TO: ALL ROOTES GROUP DEALERS  
MODEL: HILLMAN-SUNBEAM & HUMBER  
SUBJECT: FLASHER SWITCH WITH DELRING SPRING

SERVICE BULLETIN NO. N-3 - ELECTRICAL SYSTEM

FLASHER SWITCH STRIKER

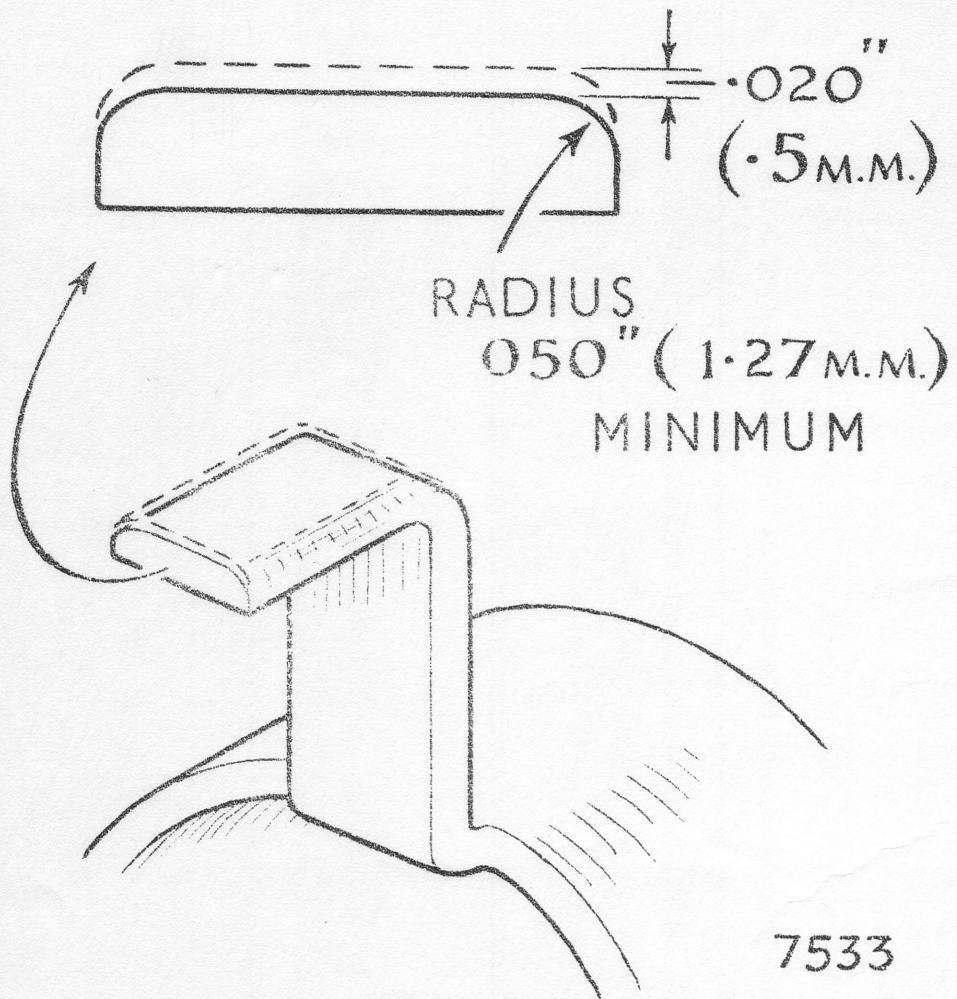
2. The striker face should be reduced by approximately .020" (.5 mm) in accordance with the accompanying illustration.

At the same time, it is important that the .050" (1.27 mm) minimum radius is reformed, otherwise the striker will impinge too abruptly onto the Delrin material and lead to a further failure.
